**GENOA CHARTER TOWNSHIP
PLANNING COMMISSION PUBLIC HEARING
MONDAY, APRIL 11, 2016
6:30 P.M.**

Attention:	Kelly Van Marter, AICP Assistant Township Manager and Planning Director
Subject:	Howell Medical Building – Site Plan Review #2
Location:	2765 E. Grand River Avenue – north side of Grand River, east of Meadowview Drive
Zoning:	GCD General Commercial District

**Re: Howell Medical Center
Site Plan Review #2**

KEBS, INC. KYES ENGINEERING
 BRYAN LAND SURVEYS
 2116 HASLETT ROAD, HASLETT, MI 48840
 PH. 517-339-1014 FAX. 517-339-8047
 Marshall Office
 Ph. 269-781-9800
Howell Medical Building
 SITE & UTILITY PLAN

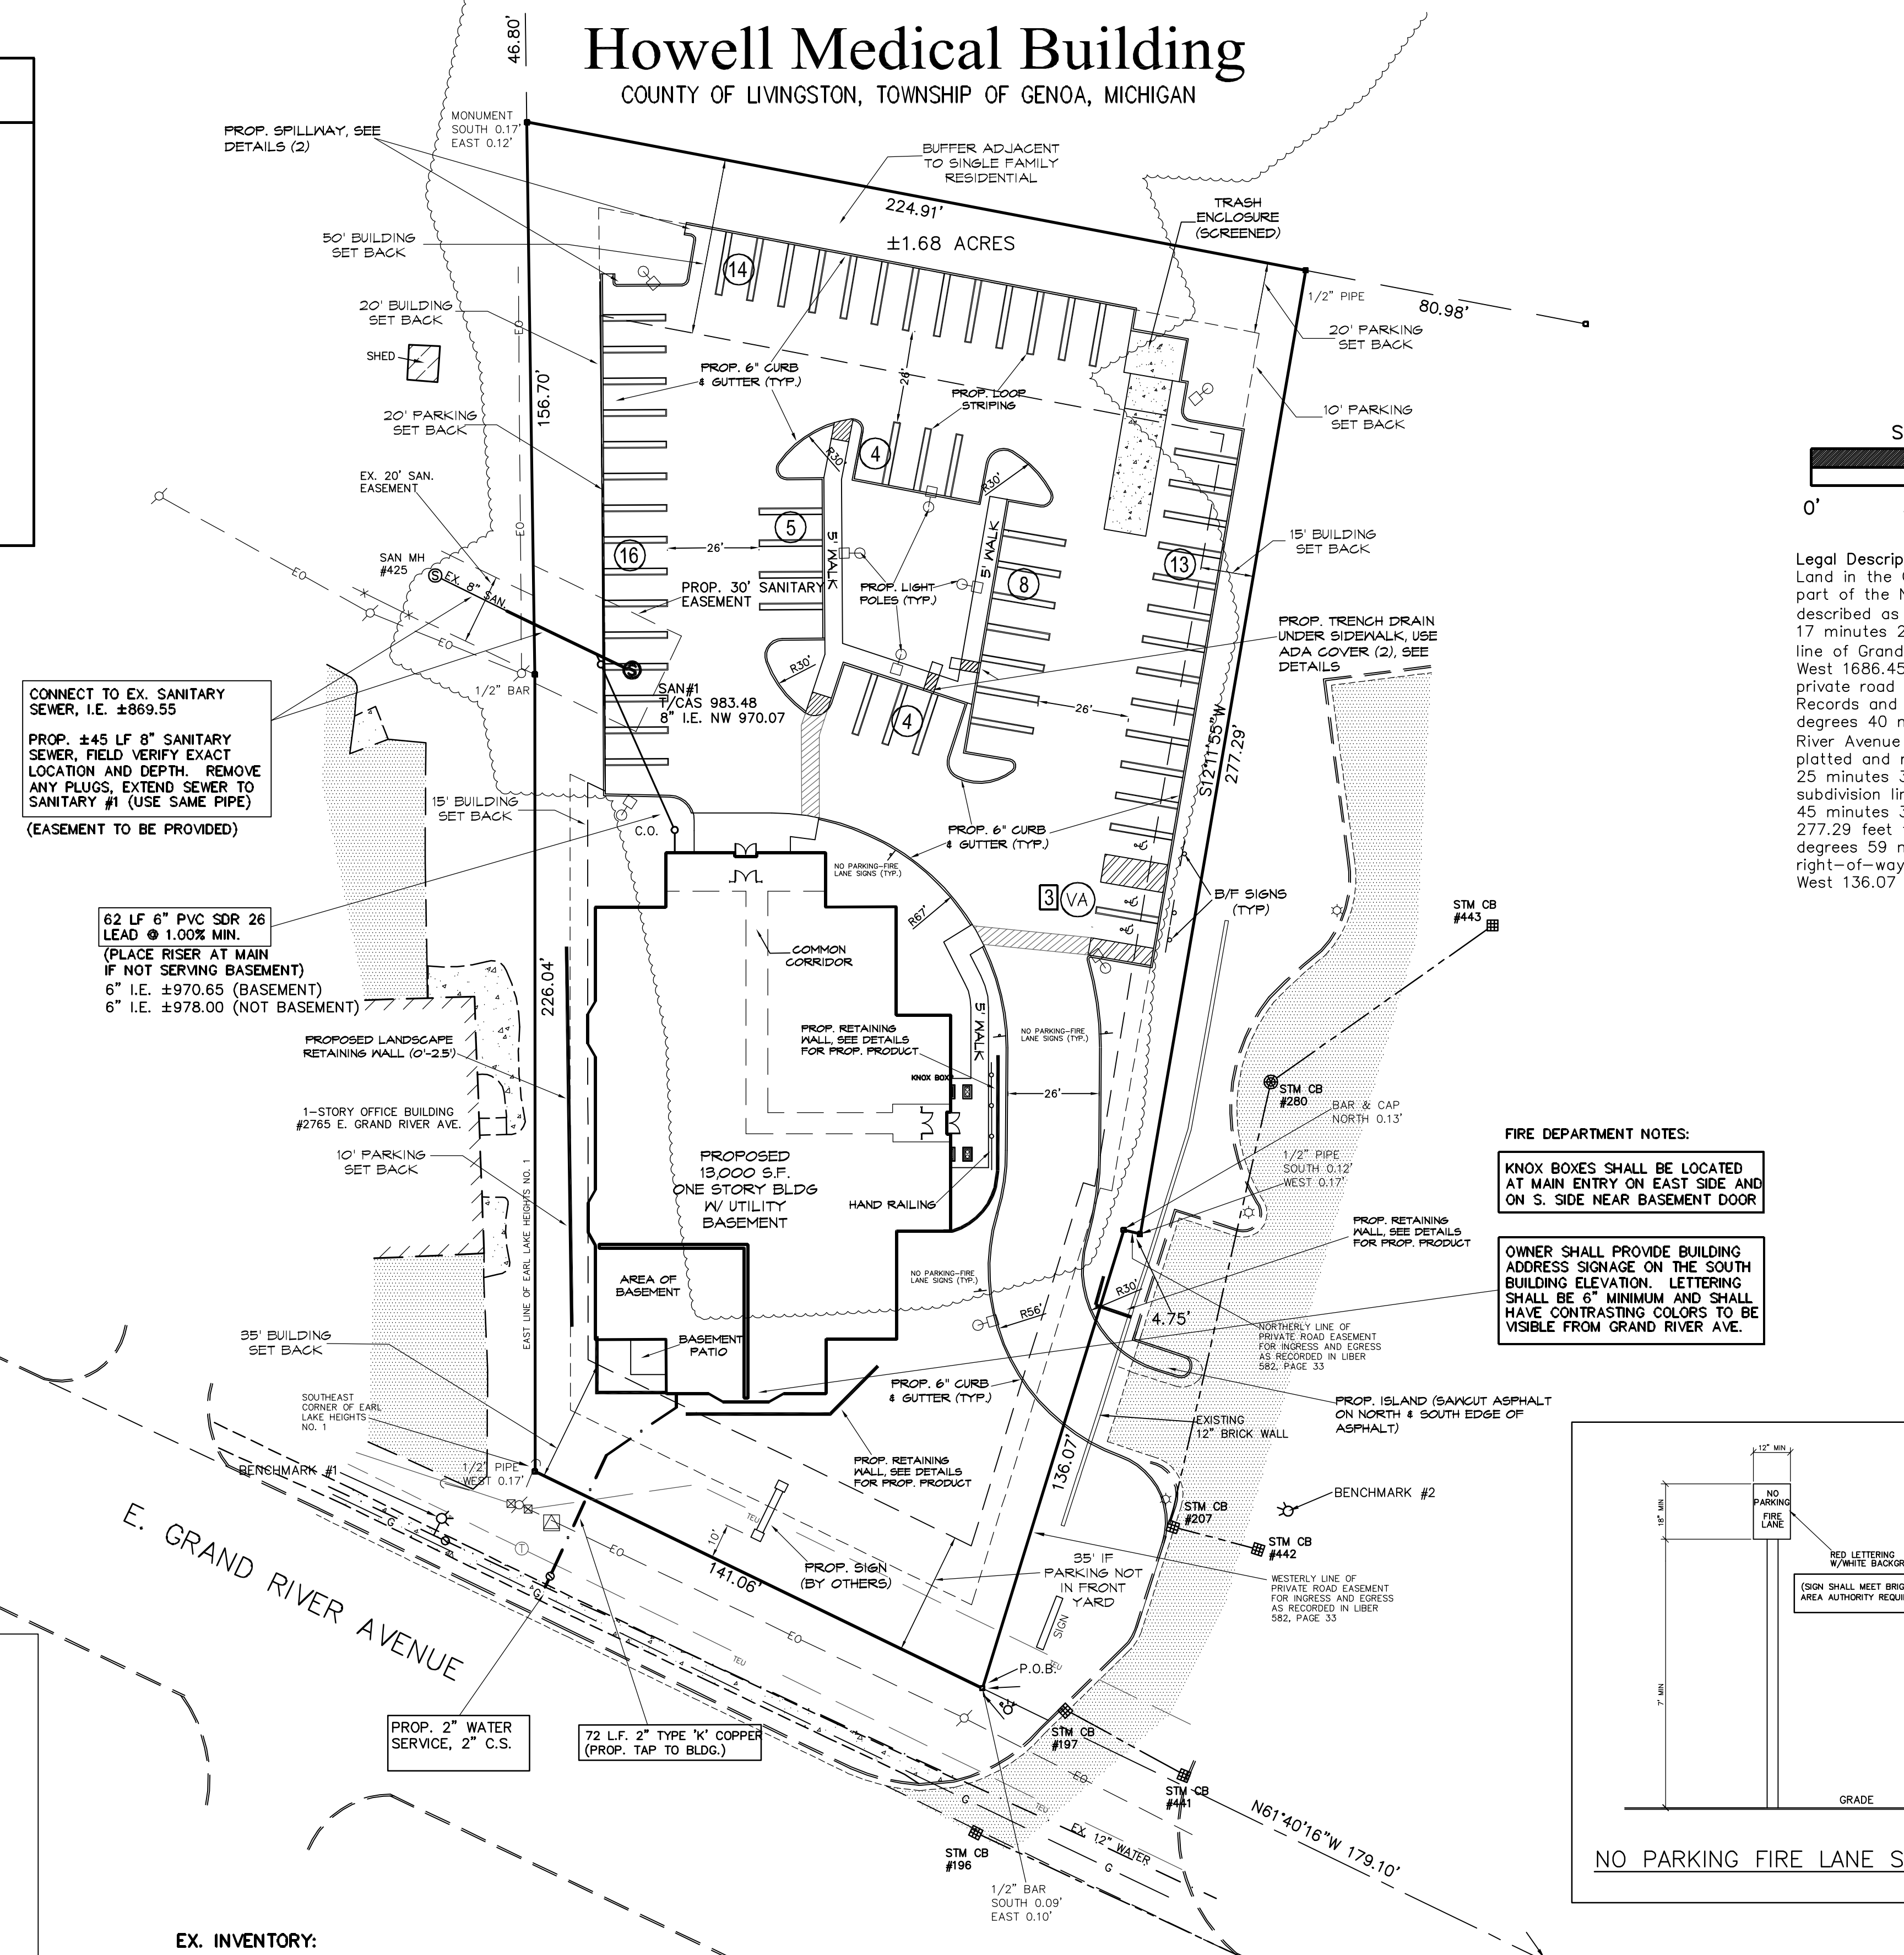
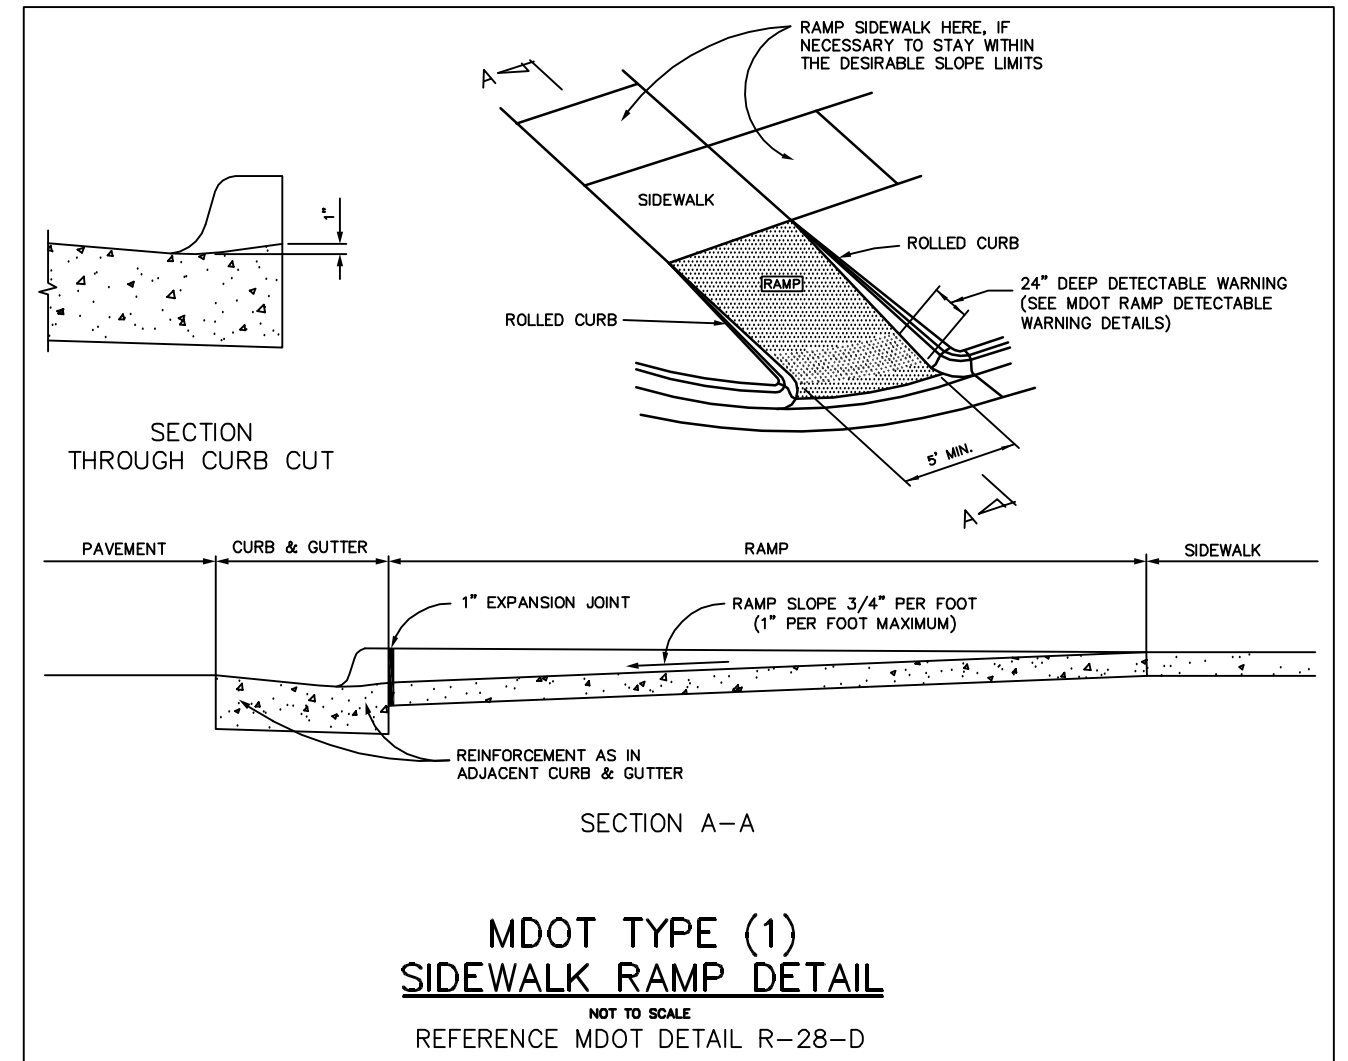
1. It appears that the building will be provided with an automatic sprinkler system based upon the presence of a 6" fire protection water line. The FDC shall be installed on the street side (Grand River). **(Revised on Drawing, building and basement are exempt from Fire Suppression, MBC 903.2.11.1)**

IFC 903
2. The address to the building shall be a **minimum of 6"** high letters of contrasting colors and be clearly visible from the street (South Elevation). The location and size shall be verified prior to installation. **(Noted on Drawing)**

IFC 505.1
3. The access drive into the site shall be a minimum of 26' wide, and maintained at that width for circulation throughout the site. With a width of 26' wide the building side shall be marked as a fire lane. Include the location of the proposed fire lane signage and include a detail of the fire lane sign in the submittal. Access roads to site shall be provided and maintained during construction. Access roads shall be constructed to be capable of supporting the imposed load of fire apparatus weighing at least 75,000 pounds. Provide an emergency vehicle circulation diagram on plan. **(Revised on Drawing)**

IFC D 103.6
IFC D 103.1
IFC D 102.1
IFC D 103.3
4. Access through the site shall provide emergency vehicles with a turning radius up to 50' outside and 30' inside while providing a minimum vertical clearance of 13 ½ feet. **(Noted on Drawing)**
5. The location of a key box (Knox Box) shall be indicated on future submittals. The Knox box will be located adjacent to the front door of the structure. There shall also be a Knox box placed at the basement door. **(Noted and Shown on Drawing)**

FIRE DEPARTMENT NOTES:
 KNOX BOXES SHALL BE LOCATED AT MAIN ENTRY ON EAST SIDE AND ON S. SIDE NEAR BASEMENT DOOR

OWNER SHALL PROVIDE BUILDING ADDRESS SIGNAGE ON THE SOUTH BUILDING ELEVATION. LETTERING SHALL BE 6" MINIMUM AND SHALL HAVE CONTRASTING COLORS TO BE VISIBLE FROM GRAND RIVER AVE.

SANITARY SEWER LATERAL

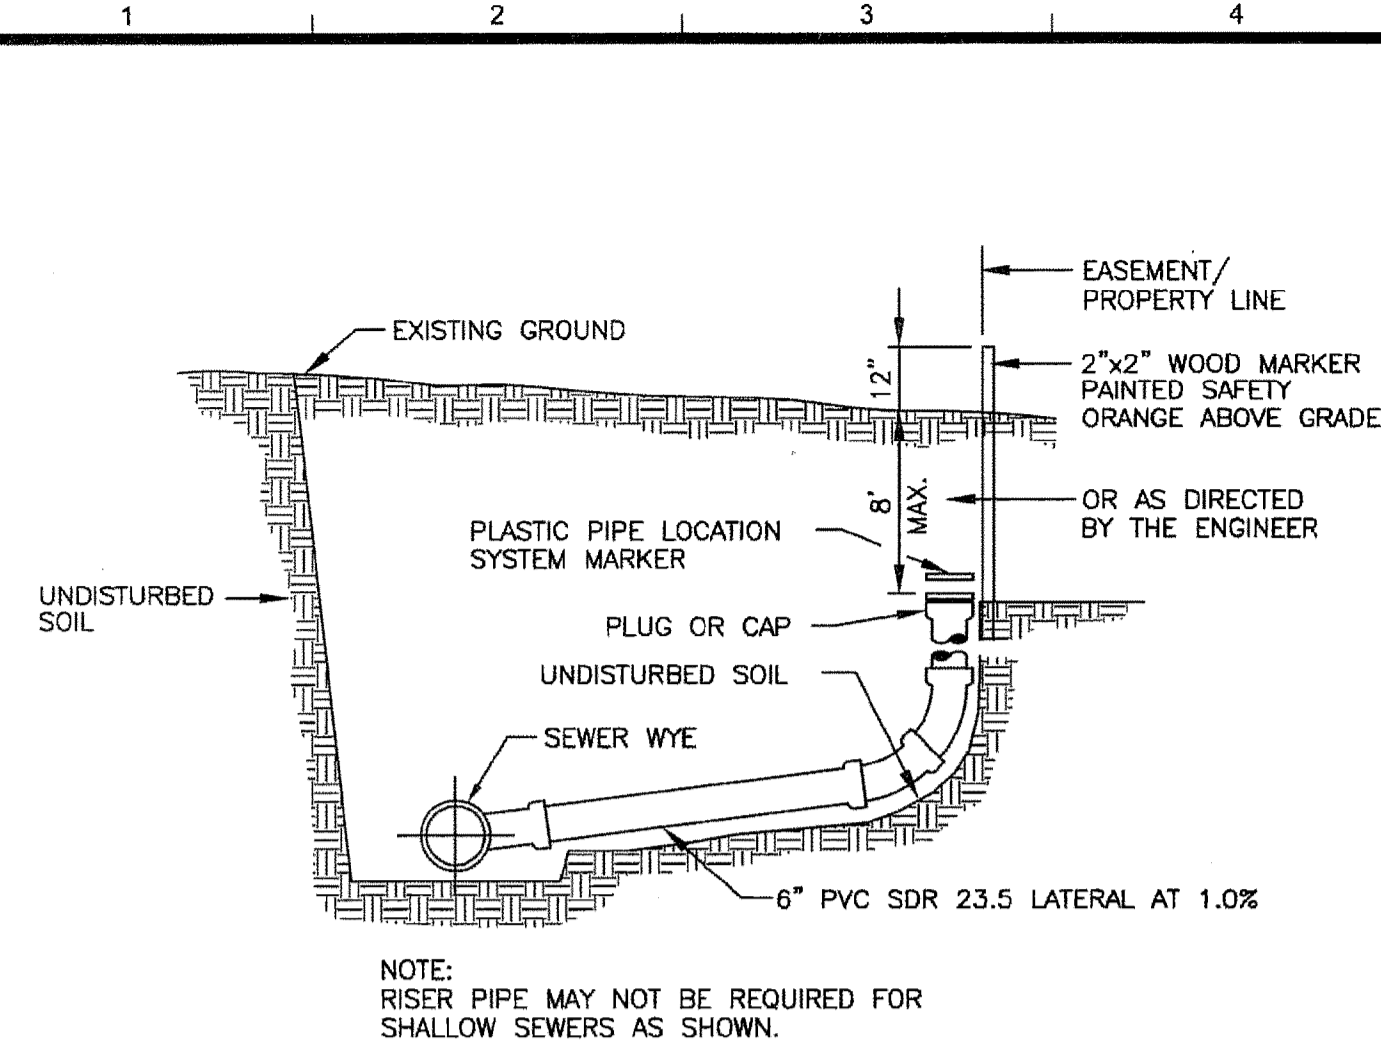
1. There is a discrepancy between the specifications listed on the cover and sheet 2 of 6 for the material called out for the sanitary service lateral. The standard material for sewer laterals is SDR 23.5 PVC. This should be corrected on the construction drawings that will be reviewed for the public sanitary sewer extension.

The petitioner has satisfactorily addressed our previous comments; therefore, we have no further objections to approval of the site plan. The above comment relating to the sanitary sewer lateral can be addressed on the construction plans.

PHOTOMETRIC SITE PLAN
1"=30'-0"

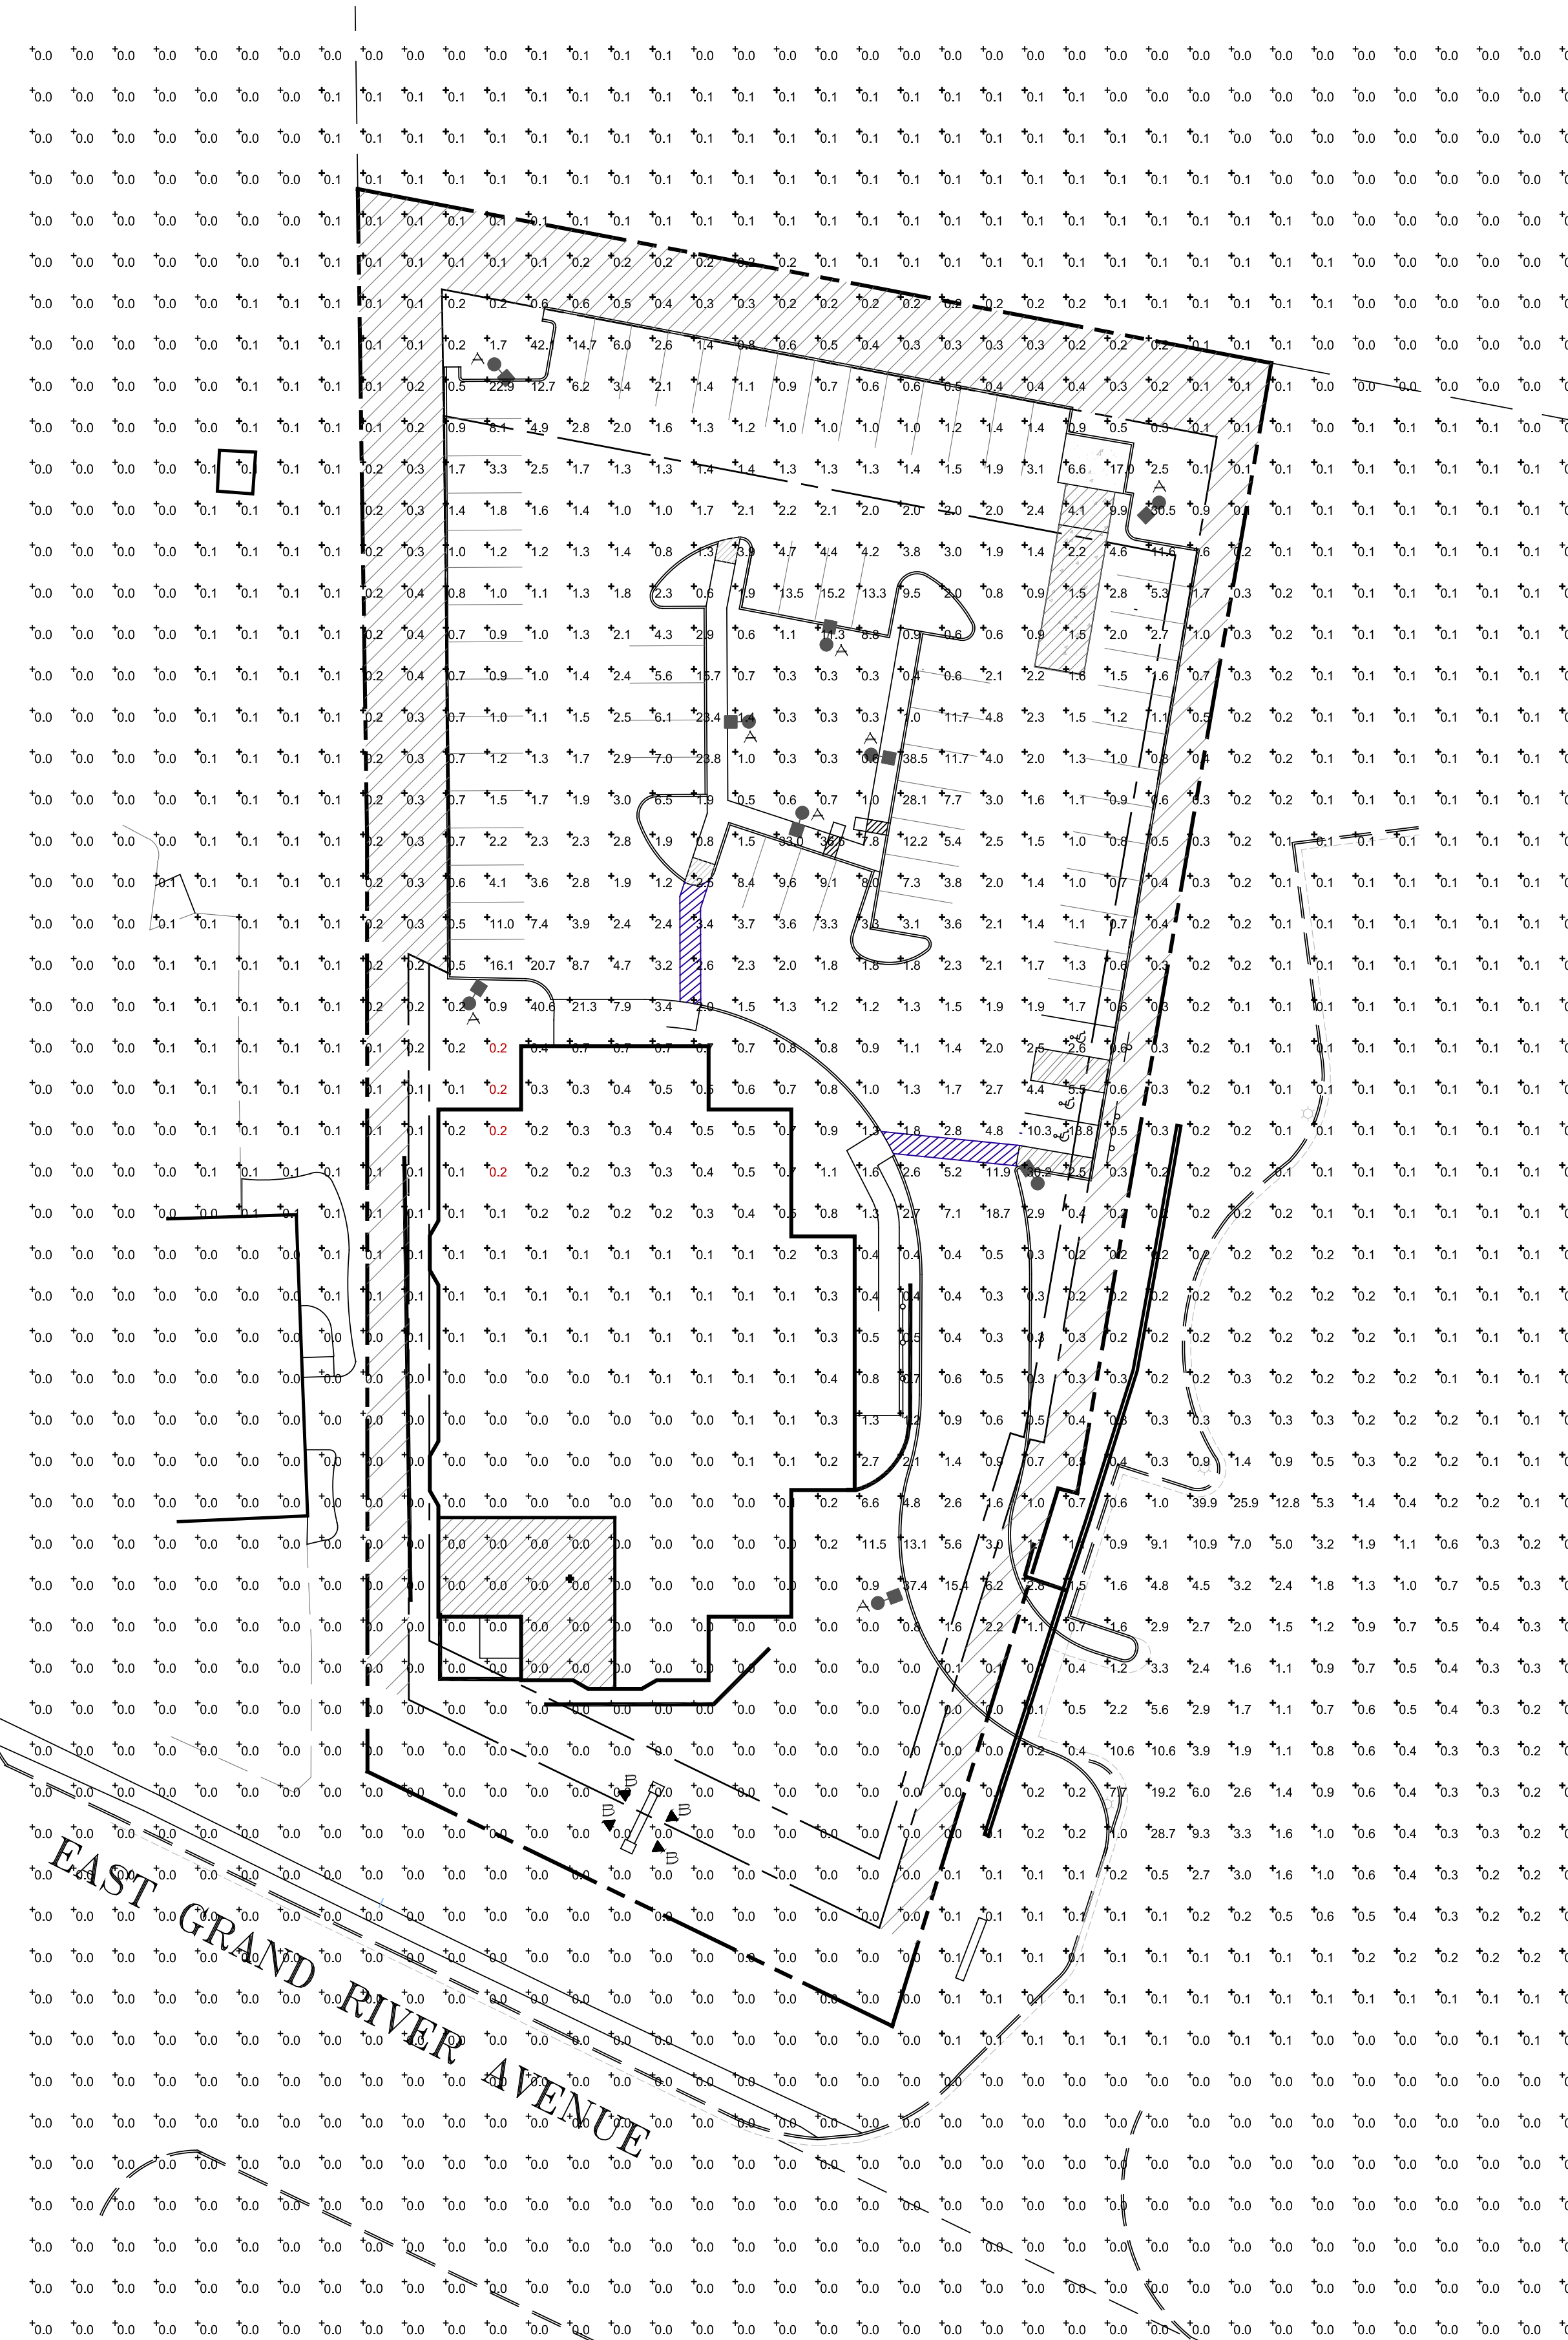
8. Exterior Lighting. The site plan proposes nine light poles for the parking lot and driveway. The photometric plan identifies several locations with light intensities well in excess of the 10-footcandle maximum. The applicant must revise the lighting plan to reduce light intensity. Light fixture details must also be provided.
